**AMENDMENTS TO THE DRAWINGS**

### **REMARKS**

### **DRAWING OBJECTIONS**

Fig. 1

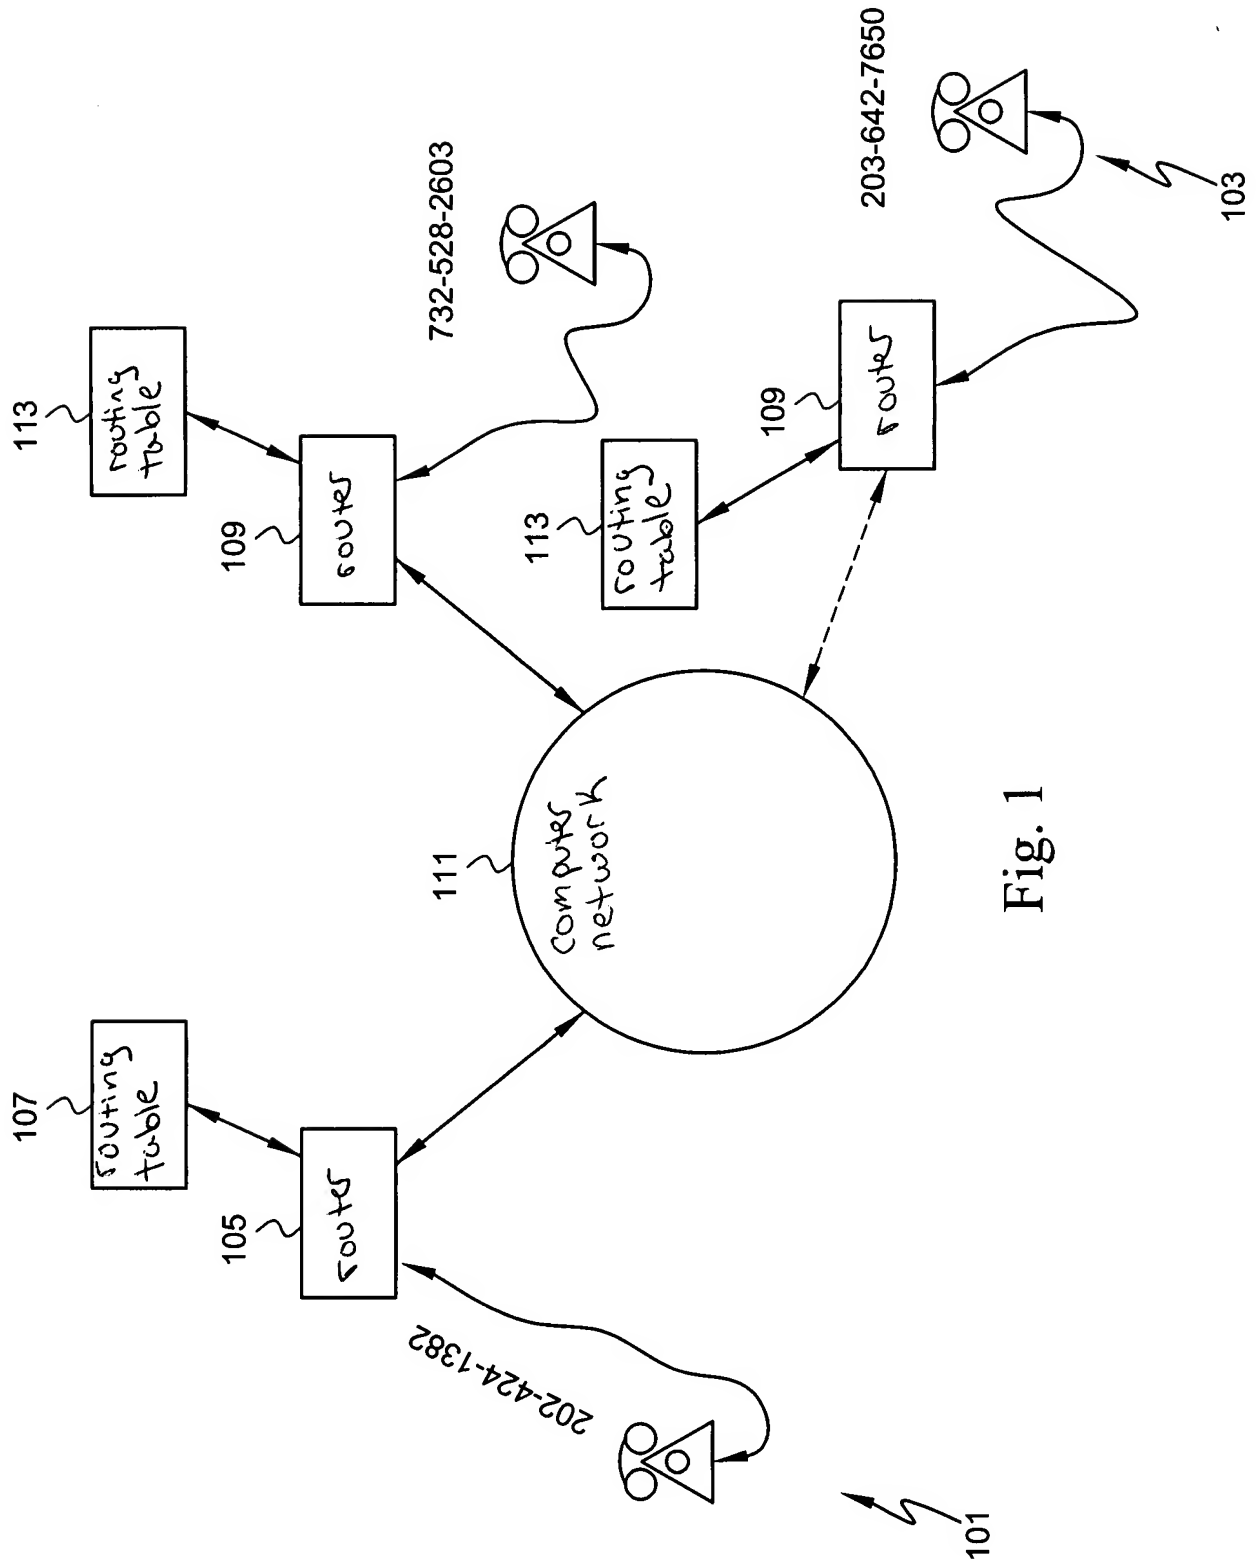
In the outstanding Office Action, FIGs. 1-3 were objected to because they “do not label for [sic] elements 105-113.” In particular, the Office Action requires text labels such as “Router” for element 105.

Despite there being no basis for requiring the labels indicated by the outstanding Office Action, Applicant submits replacement figures including textual labels only to expedite prosecution. Accordingly, it is respectfully requested that the objections to FIGs. 1-3 be withdrawn.
